Response to Reviewers

Manuscript title: Surrogate-conditioned optimizer ranking in block-scale urban energy design: A comparison of policy learning and Pareto search

Manuscript ID: APEN-D-26-08148

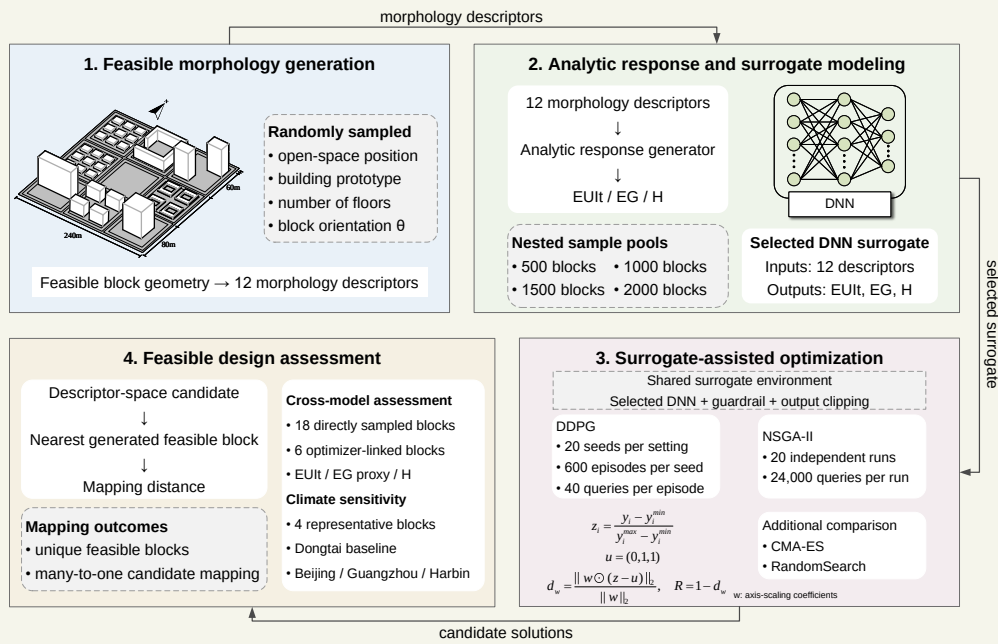
Figure 1: The caption should be improved to explain the content of the figure in more detail.

We thank the reviewer for this helpful suggestion. We agree that the original Fig. 1 caption was too brief for a workflow figure that introduces the full methodology. In the revised manuscript, Fig. 1 is used to orient the reader before the detailed method sections, so the caption now explains the main computational stages rather than only naming the figure.

We revised both the paragraph before Fig. 1 and the figure caption. The paragraph now explains that the study distinguishes generated feasible block geometries, morphology descriptors used by the surrogate and optimizers, and locked block cases used in selected physics-based and climate-sensitive calculations. The caption then describes the workflow in order: feasible morphology generation, analytic response and surrogate modelling, surrogate-assisted optimization, and feasible design assessment.

This revision also prevents a possible misunderstanding in the original manuscript. The figure and caption now make clear that the 2000-sample benchmark uses analytic response assignment, whereas EnergyPlus- and Radiance-component calculations are used later for selected locked cases in the cross-model stress test and climate sensitivity analysis.

We made this distinction in the caption itself because readers often use Fig. 1 as the entry point to the method. The revised caption therefore carries the workflow boundary before readers reach the more detailed equations and result sections.

Main manuscript, Fig. 3.

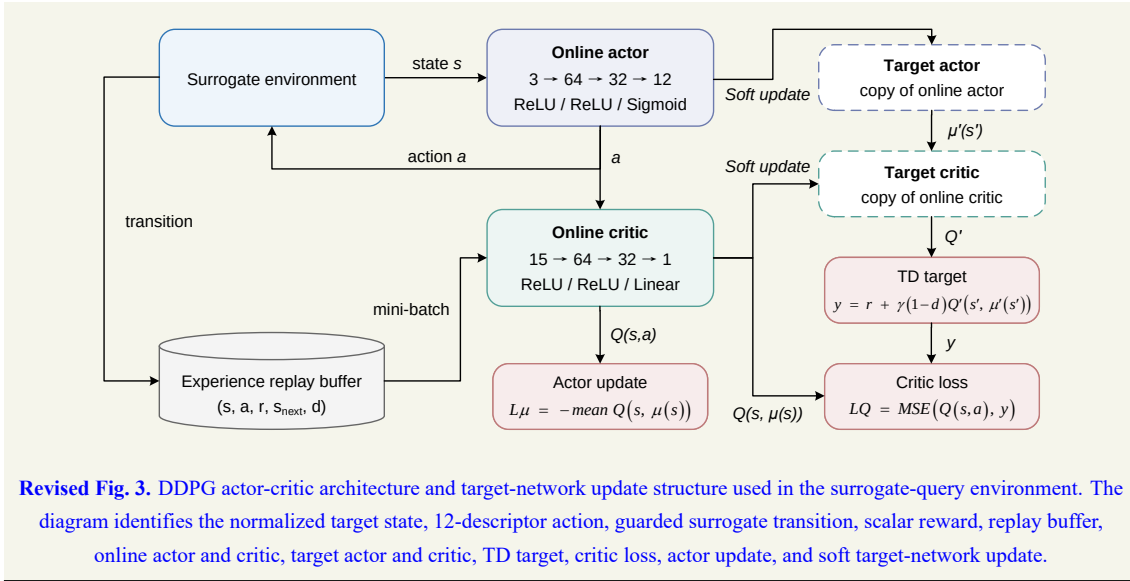
Figure 3: The manuscript does not include the explanation of the Figure 3. Moreover, the authors need to explain the symbols and equations in the Figure 3.

We thank the reviewer for this comment. We agree that the previous manuscript did not explain Fig. 3 sufficiently. The figure contained the actor-critic architecture and update equations, but the surrounding text did not define the state, action, reward, target networks, temporal-difference target, critic loss, and actor update in enough detail.

We revised Section 2.4 and the Fig. 3 caption. The revised text now defines the DDPG state as the normalized three-target vector, the action as the absolute 12-dimensional normalized descriptor query, and the reward as $R = 1 - d_w$. It also explains the online actor, online critic, target actor, target critic, replay buffer, TD target, critic loss, actor update, and soft target-network update shown in Fig. 3.

We also added the reward equations directly in the manuscript. The equations define the normalized target coordinate z_i , the ideal vector $\mathbf{u} = [0, 1, 1]^T$, the weighted normalized distance d_w , and the reward $R = 1 - d_w$. This removes the previous reward-offset wording and makes the symbols in Fig. 3 consistent with the method text.

We made three corresponding revisions. First, we expanded Section 2.4 to define the DDPG components. Second, we redrew Fig. 3 as a static surrogate-query architecture diagram. Third, we added the corrected normalization and reward equations.

Revised Fig. 4. Descriptor coverage and cross-validated surrogate predictions.

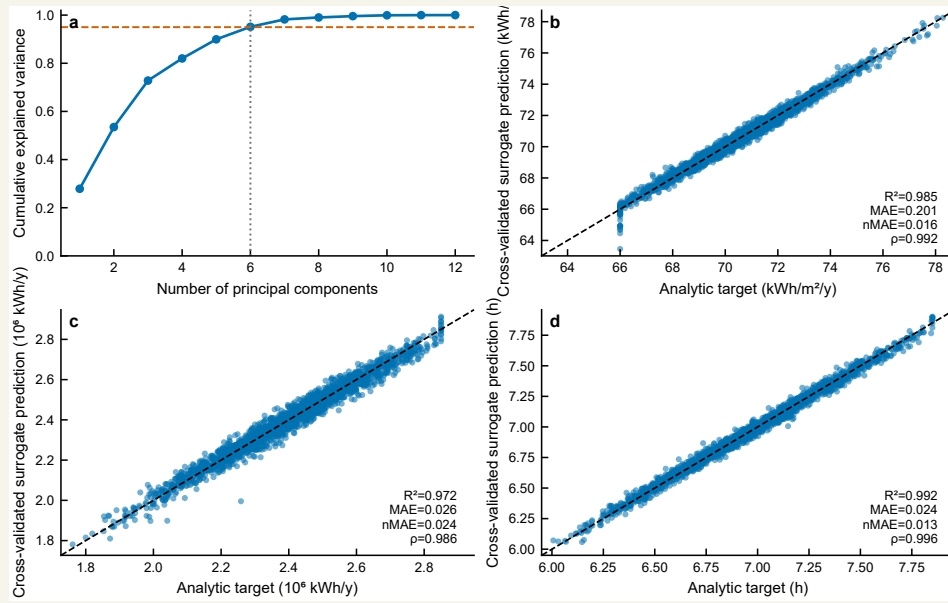
Figure 4: For parity plots, the ticks and limits of the x- and y-axes should be same. All plots should be rescaled. Please specify unit in each axis.

We revised Figs. 4, 5, and 9, Tables 1, 3, and 6, and Supplementary captions and tables to standardize target units, morphology units, one-to-one reference lines, and figure captions. The revised text now states the change and its interpretation directly.

The revised figures and tables label EUIt in $\text{kWh m}^{-2} \text{y}^{-1}$, EG in 10^6kWh y^{-1} where that scale is used, H in hours, and morphology quantities by their unit or type. This correction changes presentation only; the underlying numerical results are unchanged.

Revised Fig. 6. DDPG training trajectories across the three preference scenarios.

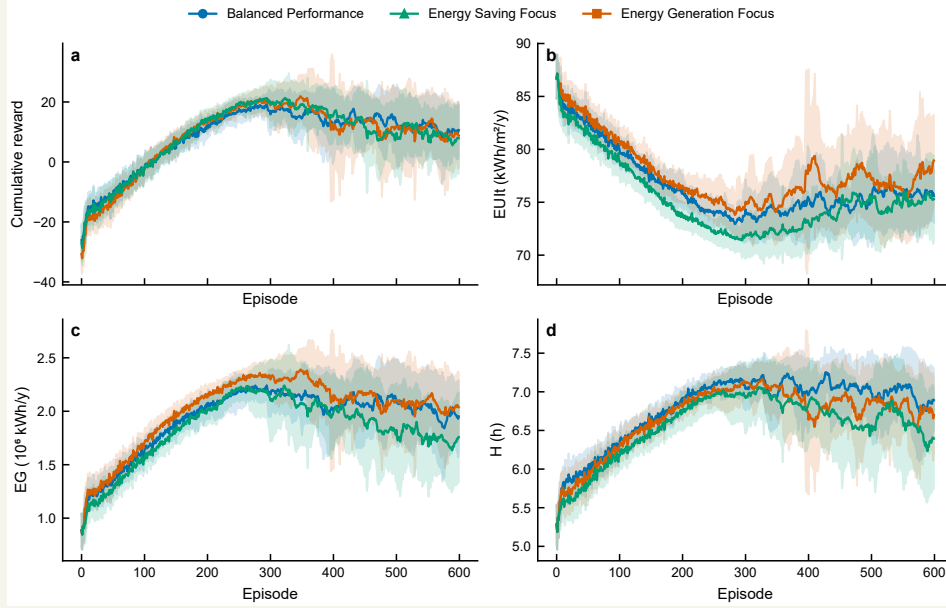
Figure 6: Please explain what the episode means in the plots.

We revised Sections 2.4 and 3.2, Figs. 2 and 6, and Supplementary Section S3.1 to define one episode as 40 surrogate-query steps and align the training-curve captions with that definition. The revised text now states the change and its interpretation directly.

We made three corresponding revisions. First, we rewrote the episode definition in Section 2.4. Second, we revised Fig. 2 and Fig. 6 captions around surrogate-query steps. Third, we added supporting detail on seed-level DDPG behaviour in Supplementary Section S3.1.

Revised Fig. 2. Serialized DDPG surrogate-query workflow. Each episode contains 40 absolute descriptor queries.

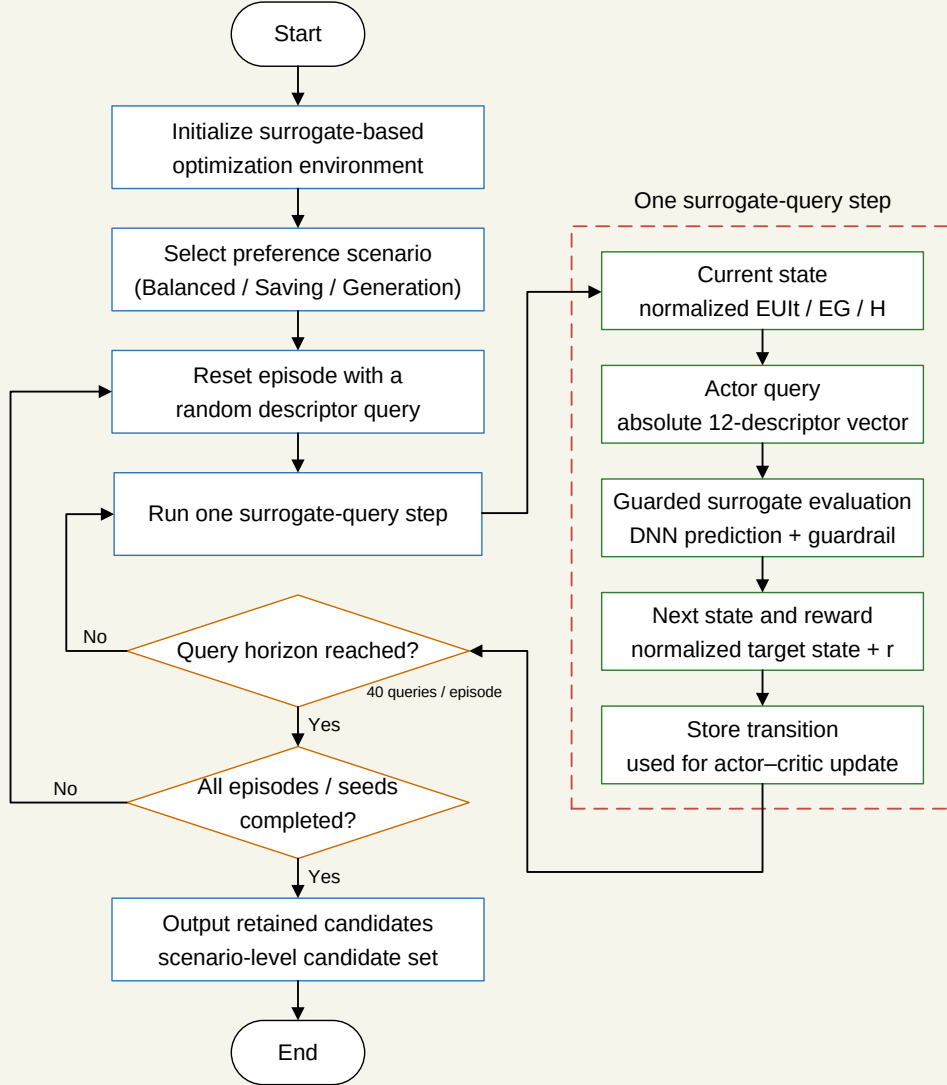
The RL formulation remains questionable because the problem is essentially a static black-box optimization problem rather than a naturally sequential decision-making process. The state transition is determined by the surrogate response to a morphology vector, and the sequential meaning of episodes and steps is unclear.

We made four corresponding revisions. First, we rewrote Section 2.4 around the static surrogate-query environment. Second, we revised Figs. 2 and 3 to explain the serialized query workflow and actor-critic update. Third, we corrected the reward equations. Fourth, we revised Section 3.2 and Supplementary Section S3.1 to clarify that episodes describe training behaviour on a static response surface.

Main manuscript, Fig. 1.

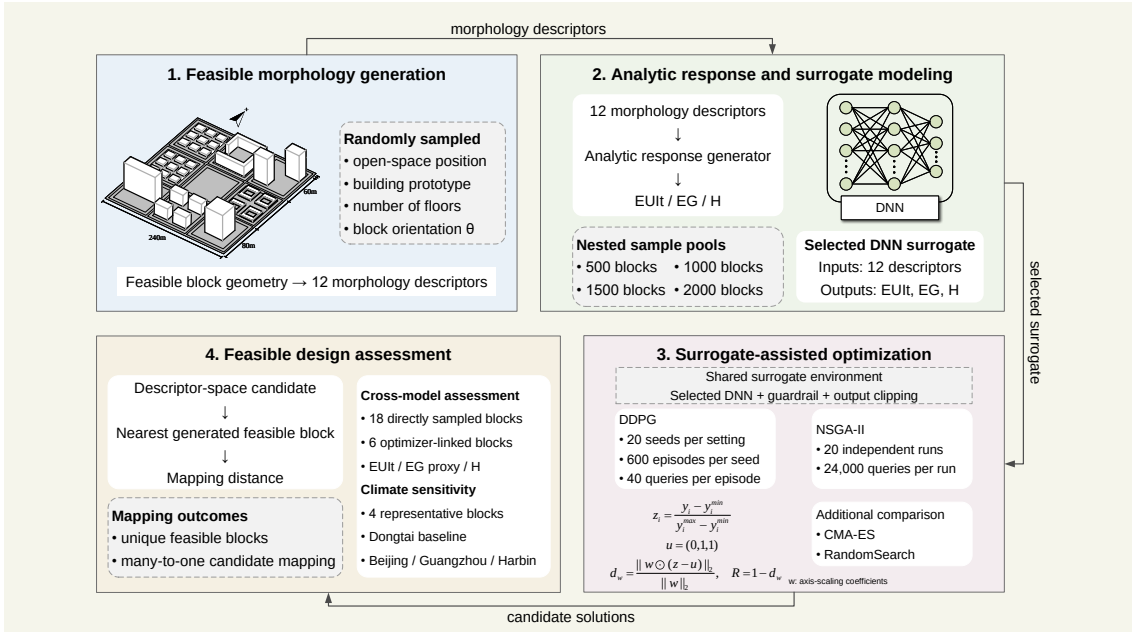
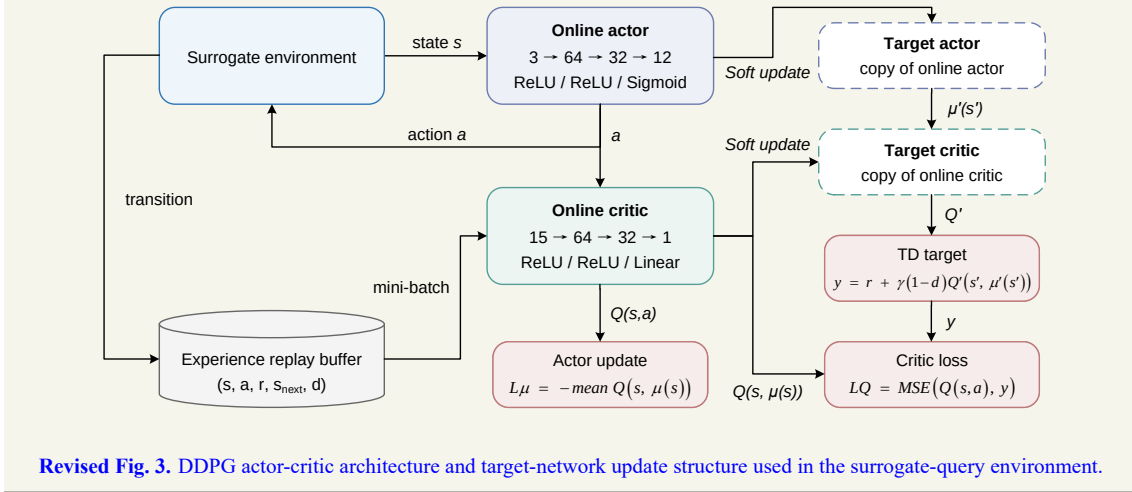
Correct spelling and wording errors in the workflow figures. For example, Fig. 1 still contains visible typos such as "loactions," "Acotr network," and "Critic network," which should be revised to "locations," "Actor network," and "Critic network."

We revised Fig. 1, Fig. 3, and their captions to correct the typo and align figure labels with the revised methodology and DDPG terminology. The revised text now states the change and its interpretation directly.

Fig. 1 now uses consistent workflow-module labels, while Fig. 3 uses standardized labels for actor, critic, replay buffer, target networks, state, action, and reward path. This is a presentation correction and does not change the method or results.

We made two corresponding revisions. First, we corrected the typo and terminology issues in Fig. 1 and its caption. Second, we corrected Fig. 3 and its caption so that the DDPG labels match the revised method description.

Revised Fig. 7. Descriptor-space DDPG and NSGA-II comparison under fixed-domain utility and equal-size retained outputs.

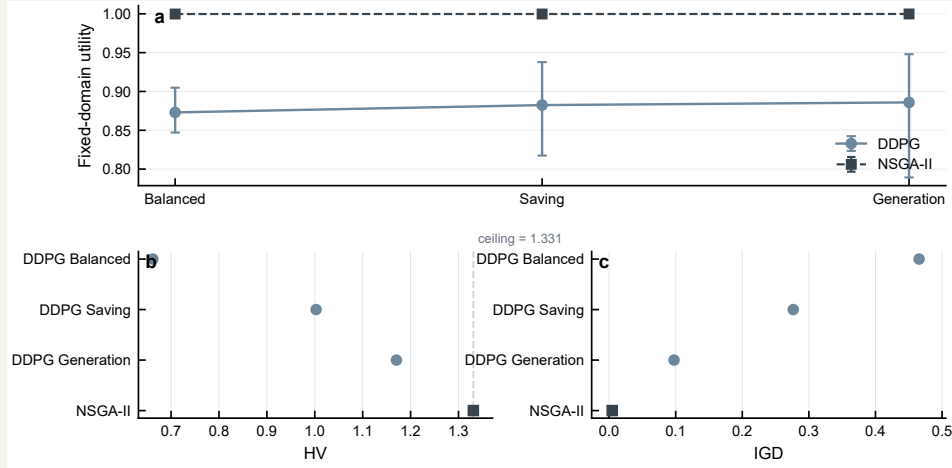
Verify the consistency between Fig. 9(d) and the stated benchmark conclusion. The text states that NSGA-II remains stronger than all DDPG scenarios, but the utility panel should be carefully checked to ensure that the plotted curves, legend, and utility direction support this conclusion.

We revised Sections 3.3 and 3.4, Table 5, Figs. 7 and 8, and Supplementary Sections S3 and S5 to rewrite the comparison around fixed-reference descriptor-space metrics, equal-size diagnostics, and projection. The revised text now states the change and its interpretation directly.

We made three corresponding revisions. First, we rewrote Sections 3.3 and 3.4 to separate scalarized candidate selection, descriptor-space HV and IGD, equal-size diagnostics, and feasible projection. Second, we revised Table 5 and Figs. 7–8 around those criteria. Third, we removed the previous utility-only interpretation from the main claim.
